RE: AMENDMENT, YARD DRAIN LOCATIONS, PACIFICORP ELECTRIC OPERATIONS, COTTONWOOD MINE, ACT/015/019, EMERY COUNTY, UTAH

**PACIFICORP ELECTRIC OPERATIONS
COTTONWOOD COAL MINE**

**AMENDMENT
STORAGE YARD DRAINS**

STORAGE YARD DRAIN LOCATIONS

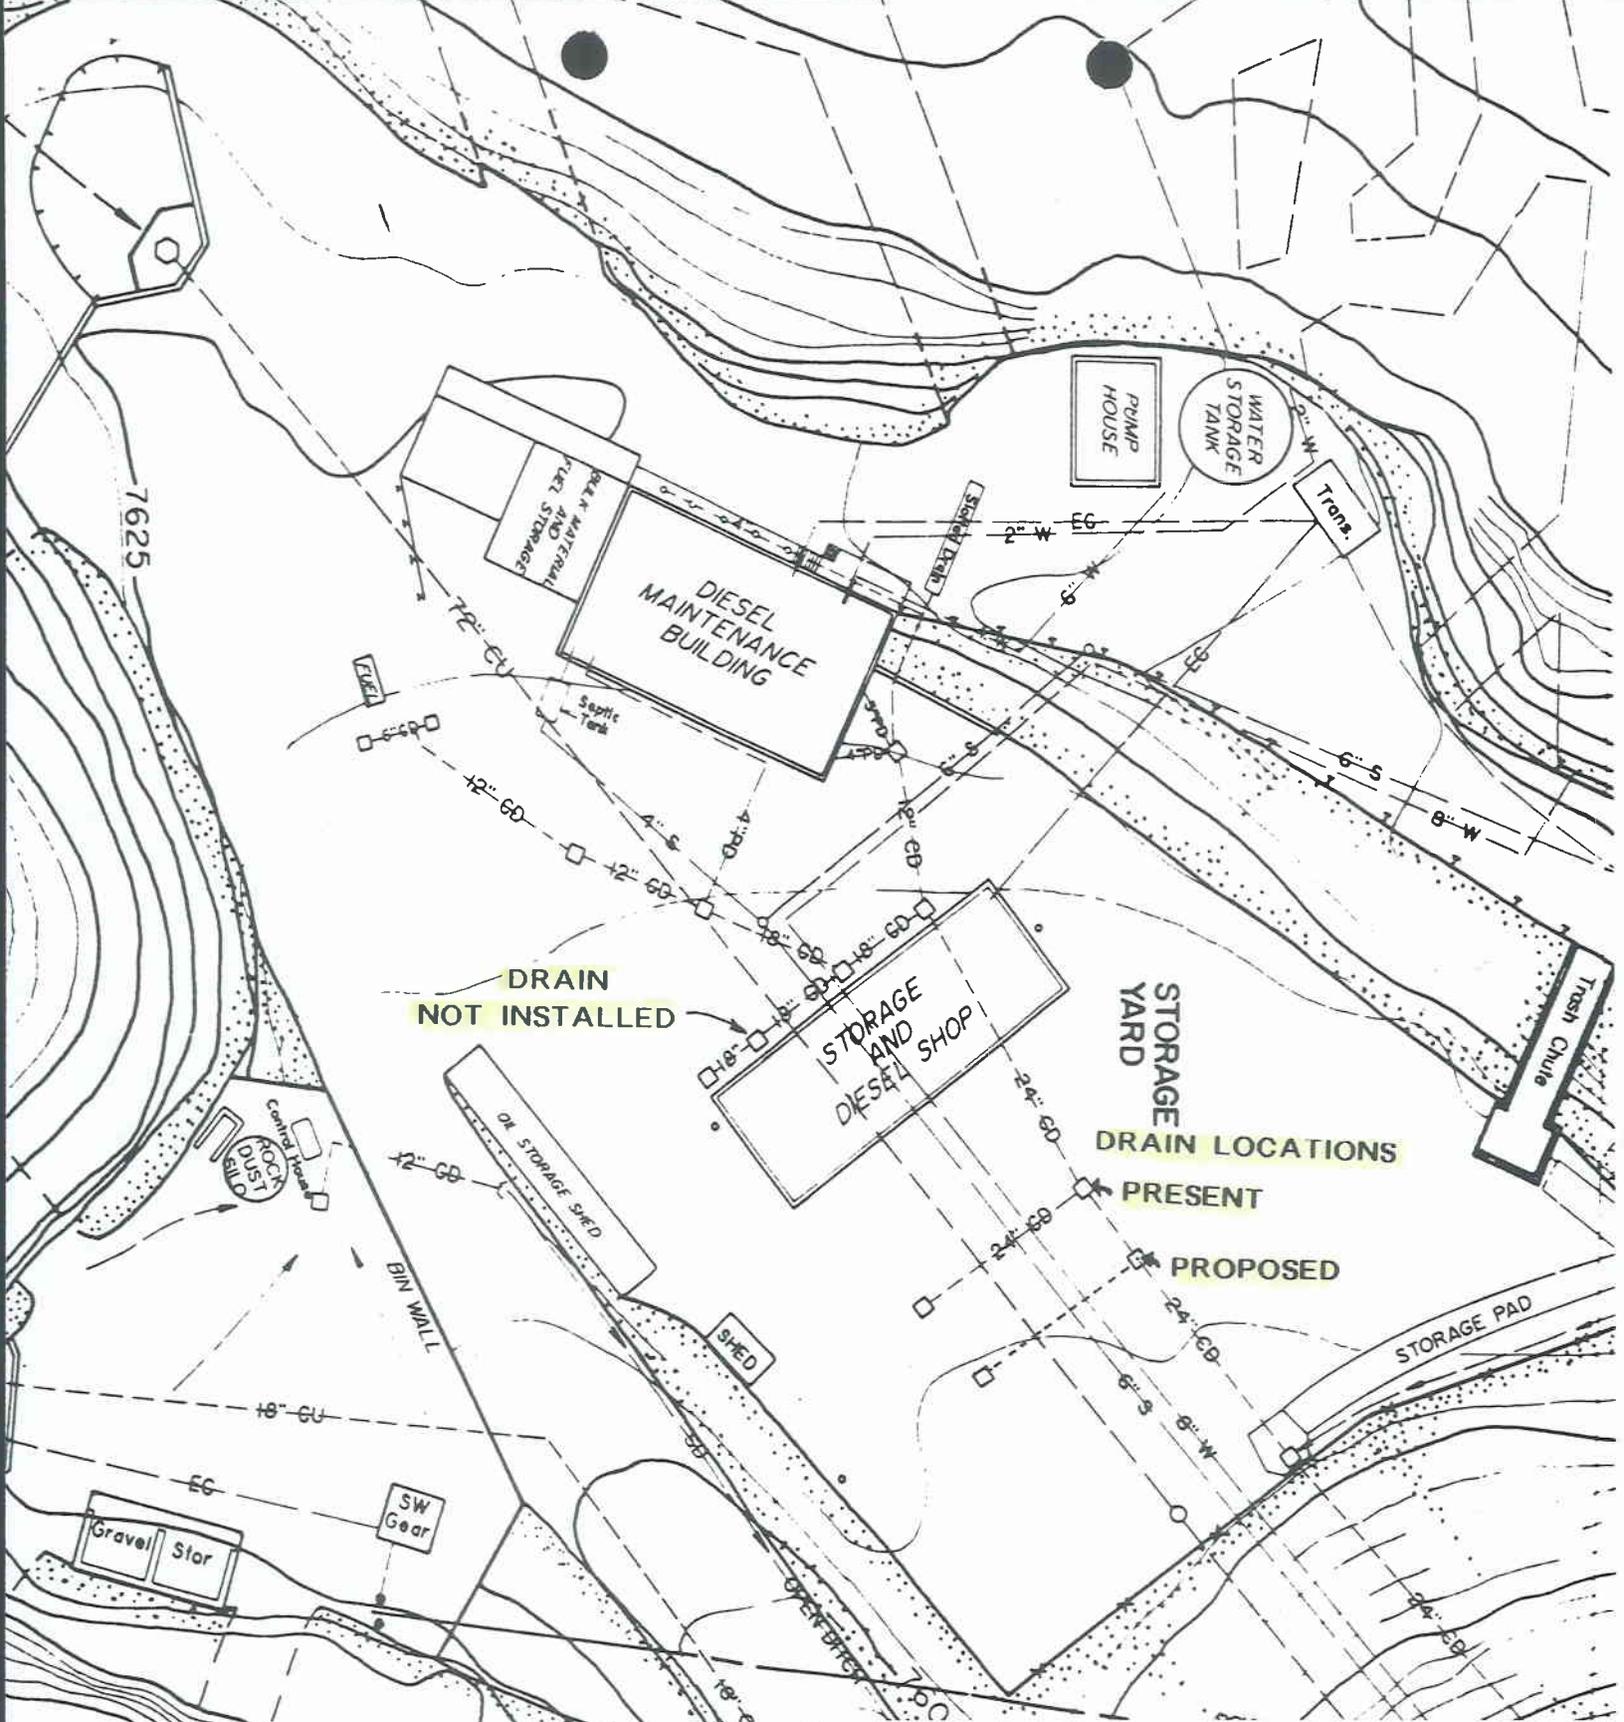
Enclosed please find information regarding the proposed relocation of two (2) storage yard surface drains at the Cottonwood Coal Mine.

The drains are presently located in an area of concentrated activity associated with bulk material handling. Therefore, they are subjected to excessive heavy equipment traffic which causes maintenance problems and deterioration of the drain structures.

Also, it has been determined that the Facilities Map is incorrect in the depiction of the drains located along the northwest side of the Storage and Diesel Shop building. Four (4) drains are shown on the map; however, only three (3) drains are in place. The capacity provided by the existing drains has proven to be adequate. Also, the presence of electrical cables and conduit in the vicinity of the fourth drain location precludes installation of the drain. Therefore, it is proposed that the Facilities Map be revised to show actual conditions.

DRAIN NOT INSTALLED

The proposed solution to the problem involves relocation of the drains approximately 25 feet southeast of their present locations as indicated in the enclosed information. The relocated drains will be constructed similar to the existing drains and will discharge into the existing 24" disturbed drainage culvert. The surrounding surface area will be graded to insure flow to the new locations.

PRESENT
PROPOSED
